**SUPPLEMENT NO. 02 TO DOC. CR-MM-1-0-00****New type of Kuntzleman landing light holder**

(the SI0664N clip replaced by the SI0670N bracket)

The Minor Change was approved under EASA Approval No.10065405, 2 May 2018.

Fig.1.- Difference between original and new Kuntzleman landing light holder.

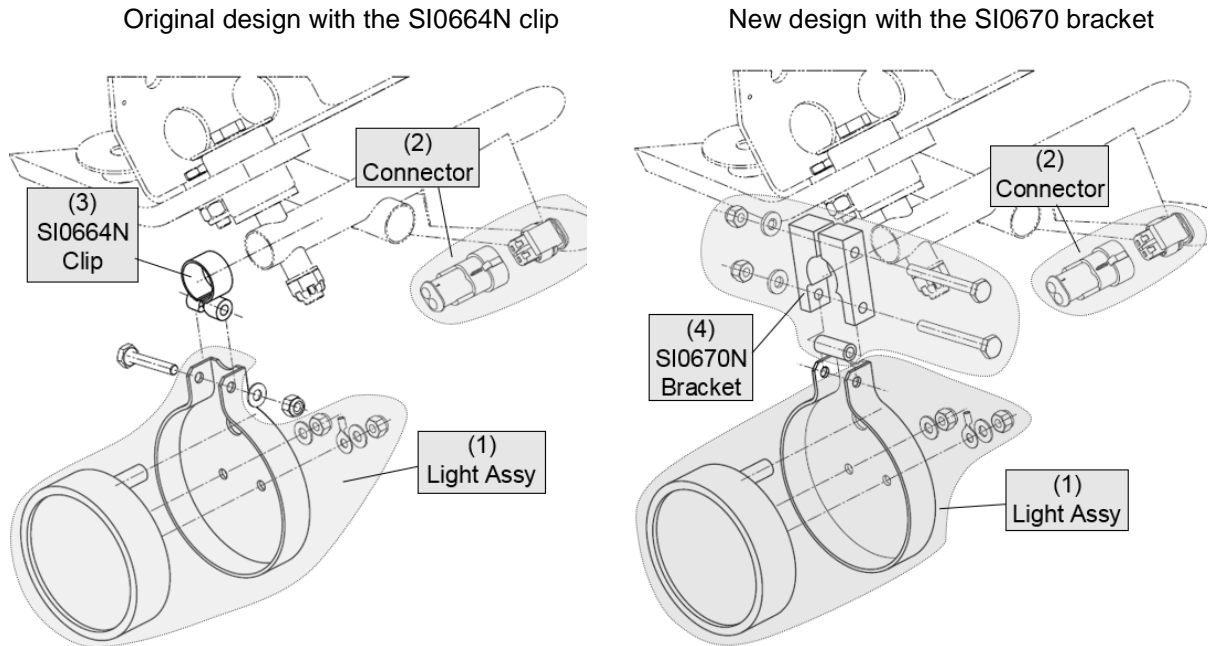
For production and technological reasons, it was decided to modify the mounting holder of the Kuntzleman 11-06854 landing light. The SI0664N clip (3) with hardware was replaced by the new SI0670N bracket (4) with hardware, see Figure 1 below.

- 1) Use the bracket (4) and attach the light assembly (1) preliminary to the engine mount, see Fig. 1 above.
- 2) Attach preliminary the engine lower cowling to the airplane and adjust mutual position of the light assembly (1) and the light cover (the light cover is a part of the engine lower cowling). Then, remove the engine lower cowling and complete mounting of the light assembly (1) and the bracket (4) to the engine mount.

**Notice:** Adjustment of mutual position of the light assembly and the light cover, shall be performed in such way that a steady space remains between the light assembly and the light cover.
